South Texas Project Electric Generating Station P.O. Box 289 Wadsworth, Texas 77483

March 30, 2010  
U7-C-STP-NRC-100064

South Texas Project  
Units 3 and 4  
Docket Nos. 52-012 and 52-013  
Response to Requests for Additional Information

**RAI 15.08-2 Revision 1****QUESTION:**

Figure 15E-1b ATWS Mitigation Logic (SLCS Initiation, Feedwater Runback)

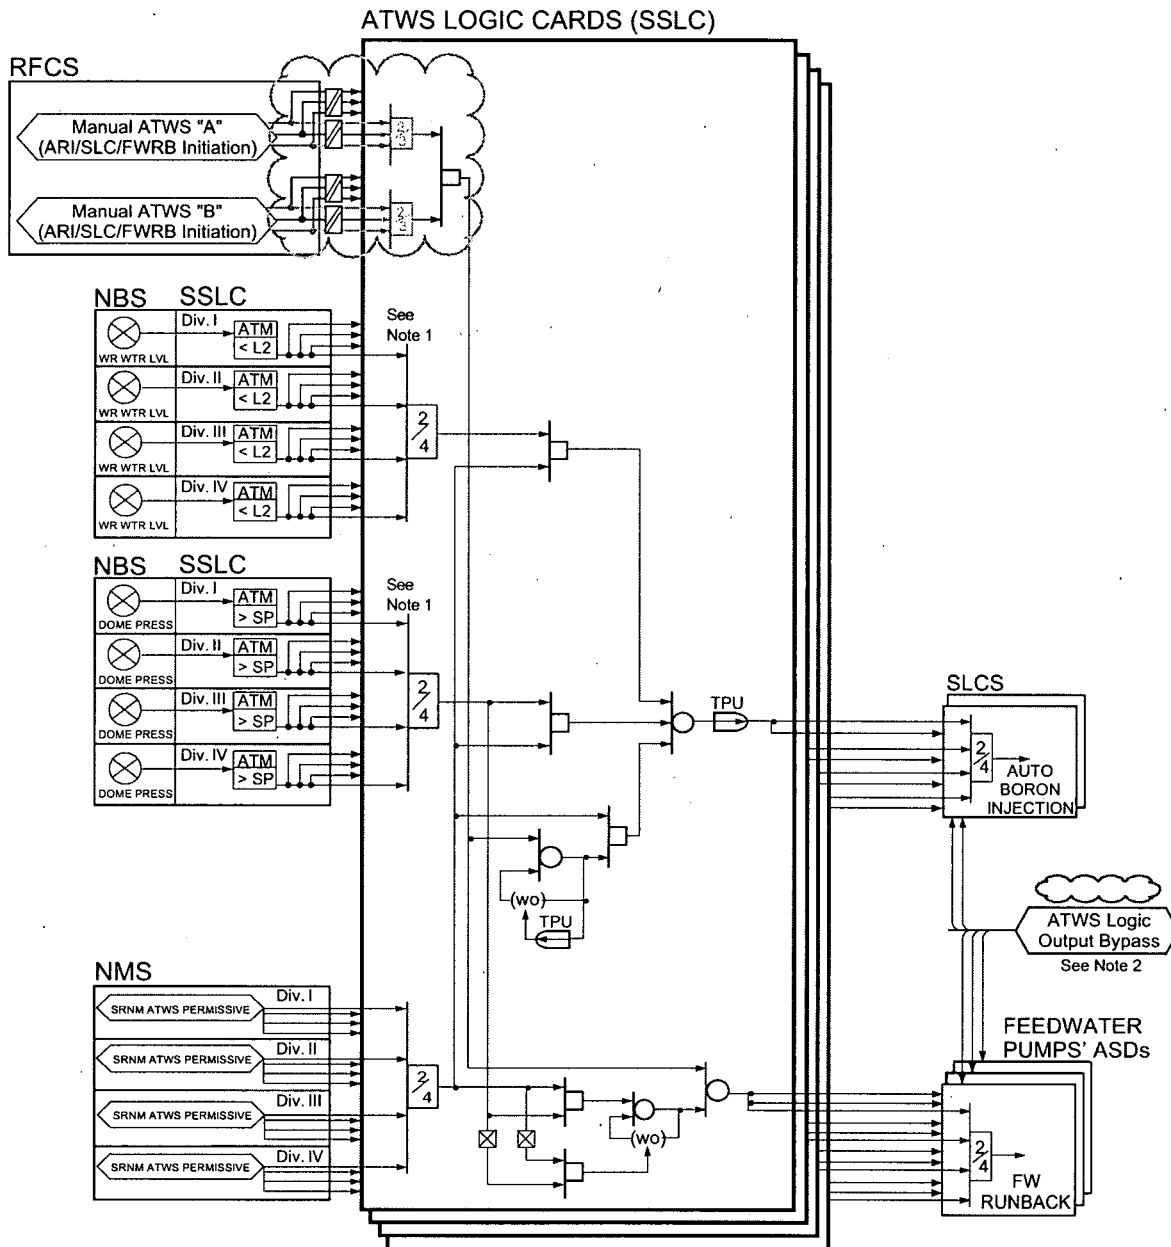
STPNOC has revised the logic in the STP 3 & 4 FSAR Figures 15E-1a, "ATWS Mitigation Logic (ARI, FMCRD Run-In, RPT, Manual Initiation)," 15E-1b, "ATWS Mitigation Logic (SLCS Initiation, Feedwater Runback)," and 15E-1c, "ATWS Mitigation logic (SLCS Initiation, Feedwater Runback)" based on Tier 1 departure STD DEP T1 3.4-1 and STD DEP Admin. However, no changes have been made to the ATWS logic-related text contained in the FSAR, specifically subsections 2.2.8 and 3.4 in Tier 1, and subsection 7.4 and 15E.1 in Tier 2. Explanation of the logic changes shown on these revised FSAR figures has not been provided in either of the cited departures. It was also noted that some of the changes made to these FSAR figures are not annotated (back circled). Due to the stated reasons, NRC staff is unable to verify the acceptability of the departed ATWS mitigation logic. STPNOC is asked to provide an explanation for all marked and unmarked logic changes shown on the revised FSAR figures 15E-1a, 15E-1b, and 15E-1c.

**Figure 15E-1b**

The following changes are made to DCD Figure 15E-1b. An administrative change is made to the manual ATWS "A" & "B" initiation logic to show 2 out of 3 voting signals. This logic change to the DCD figure is correct with respect to the DCD design; however, it was not properly identified as a change on the previous COLA figure, and will be identified in a future COLA revision as shown below. This logic design is consistent with DCD Part 2, Tier 1, Sections 2.2.4 and 3.4 and Part 2, Tier 2, Subsection 7.4.1.2. An additional administrative change is made to correct the figure number in the title.

A change is made to COLA Revision 3, FSAR Figure 15E-1b to show the DCD NMS SRNM ATWS permissive 2-out-of-4 logic design. This change is also an administrative change for consistency with DCD Part 2, Tier 1, Sections 2.2.4 and 3.4 and Part 2, Tier 2, Subsection 7.6.1.1.

There are several additional changes related to the nomenclature changes identified in standard departure STD DEP T1 3.4-1. The nomenclature for trip logic units (TLUs) has changed to trip logic functions (TLFs), so "SSLC TLU" in Figure 15E-1b Note 2 becomes "TLF". Also, as discussed in STPNOC's RAI 07.02-2 response, the same departure eliminates the SSLC bypass unit as a separate entity; the logic for this unit has been incorporated in the Reactor Trip and Isolation System (RTIS).

COLA Part 2, Chapter 15, Figure 15E-1b will be revised as shown below in COLA Revision 4. All changes are shown relative to the DCD. Corresponding changes to the associated ATWS Technical Specification figures will also be made in COLA Revision 4.
